CS Memorandum No. 1411

**Subject:** Configuration Management Board Meeting No. 120

## CMB Meeting Minutes #120

SUBJECT: Configuration Management Board Meeting # 120 – Rev. No. 0

Drawing Nos. Attachment A

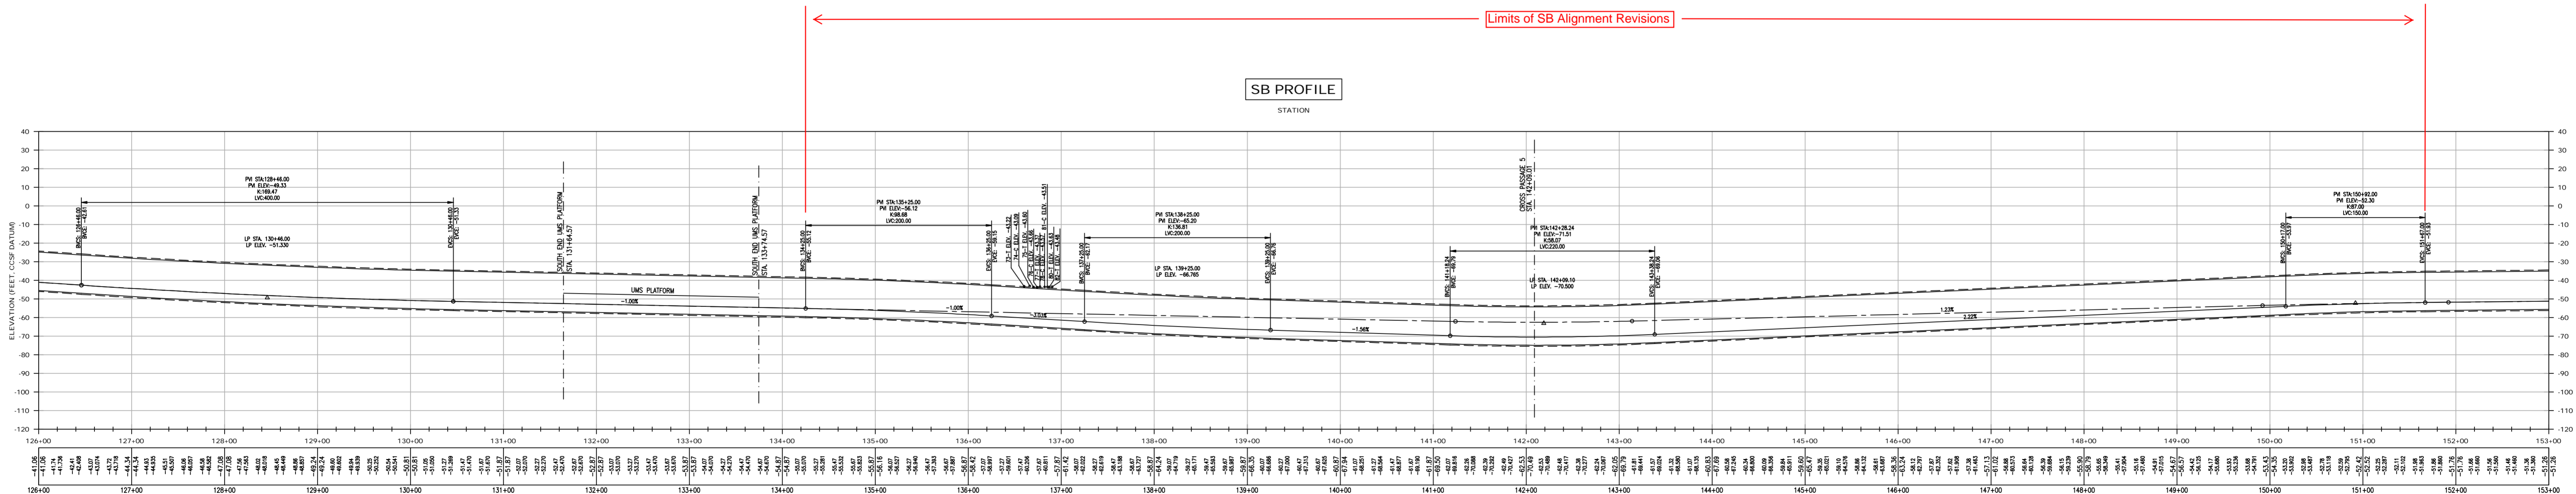
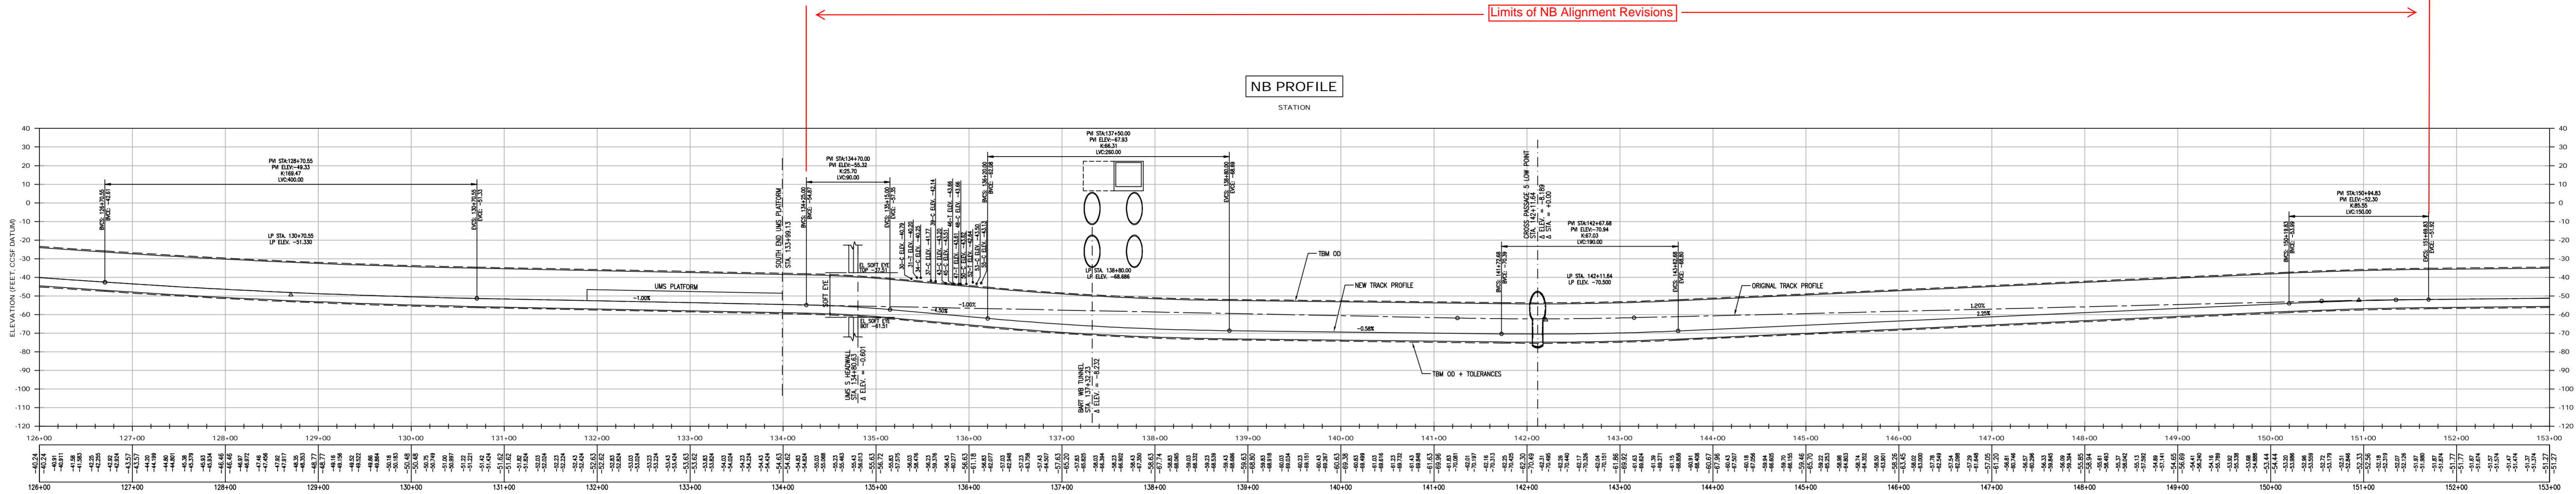
1. Modifications to tunnel alignment as required to avoid conflict with existing micropile. Modifications effect tunnel alignments between:  
 NB: STA 134+25.00 and STA 151+69.83  
 SB: STA 134+25.00 and STA 151+87.00

The modified alignments shown on the attached drawing supersedes original NB and SB alignments shown on Contract Plans TC-108 Rev.1 through TC-111 Rev.0, TC-134 Rev.1 through TC-136 Rev.0.
2. Modification to Building Protection Compensation Grouting within the Market Street Area (Pipe Arrays 1 through 3 shown on Contract Plans BP-122 Rev.0, BP-123 Rev.0 and BP-124 Rev.0). Contractor shall revise compensation grouting design to conform to Contract requirements given the revised tunnel alignment. Revised grouting plans shall be submitted to the SFMTA in accordance with Contract Specification section 31 43 14.

- A. IFB Tunnel Profile conflicts with micro-piles installed under Contract 1251.
- B. Tunnel Profile needs to be revised (lowered) such that TBM and Tunnel structure is below previously installed micro-piles.

Revise tunnel alignment. To be implemented immediately.
